# Access Compliance Report

## Public Rights-of-Way

### (Curb Ramps)

Intersection ID: 15223	Main Street: IDEAL_WY	Cross Street: SARAH_MARKS_AV	Location: SW
ADA ID: 9F8D24DB0FC7	Ramp Type: PerpDiag	Initial Pass/Fail: Fail	Overall Compliance: No
Severity Score: 12.5			
Codes/Mitigation Info/Possible Solution		Field Measurements/Component Compliance

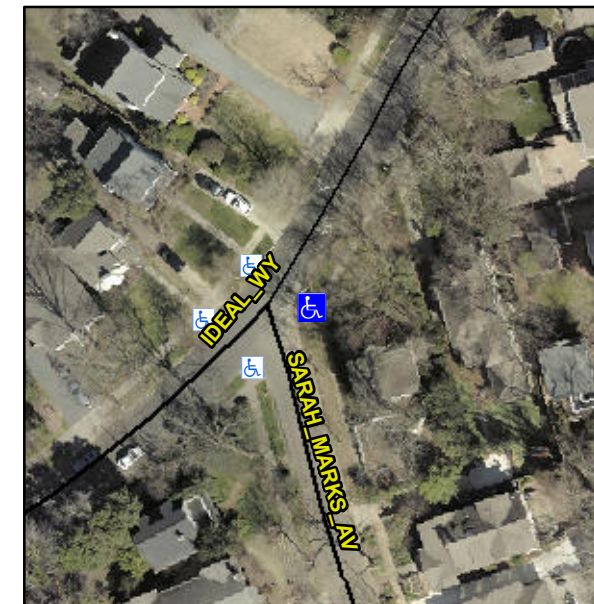
**Remove & Replace Curb Ramp With Two New Directional Ramps or Equivalent.**

**Not Found, R304.2.2**

Compliance	Description	Data	Compliance	Description	Data
N/A	Ramp Length (in)	78.0	No	Ramp Slope (%)	9.5
Yes	Ramp Width (in)	76.0	Yes	Ramp XSlope (%)	0.7
N/A	Flare Type LT	N/A	N/A	Flare Type RT	N/A
N/A	Flare Slope LT (%)	N/A	N/A	Flare Slope RT (%)	N/A
N/A	Flare Traversable LT?	N/A	N/A	Flare Traversable RT?	N/A
N/A	Landing Length (in)	N/A	N/A	DWS Provided?	N/A
N/A	Landing Width (in)	N/A	N/A	DWS Contrast?	N/A
N/A	Landing Slope (%)	N/A	N/A	DWS Length (in)	N/A
N/A	Landing X Slope (%)	N/A	N/A	DWS Full Width?	N/A
N/A	Landing Curb? (Y/N)	N/A	N/A	DWS Offset (in)	N/A
N/A	Shared Landing?	N/A			
N/A	Gutter Ponding?	N/A	N/A	Gutter Slope (%)	N/A
N/A	Gutter Lip Ht (in)	N/A	N/A	Gutter X Slope (%)	N/A
N/A	Painted X Walk1?	No	N/A	Painted X Walk2?	No
	X Walk 1 Direction	To NW		X Walk 2 Direction	To SW
N/A	X Walk 1 Width (in)	N/A	N/A	X Walk 2 Width (in)	N/A
	X Walk 1 Slope (%)	4.0		X Walk 2 Slope (%)	1.4
	X Walk 1 X Slope (%)	0.9		X Walk 2 X Slope (%)	2.6
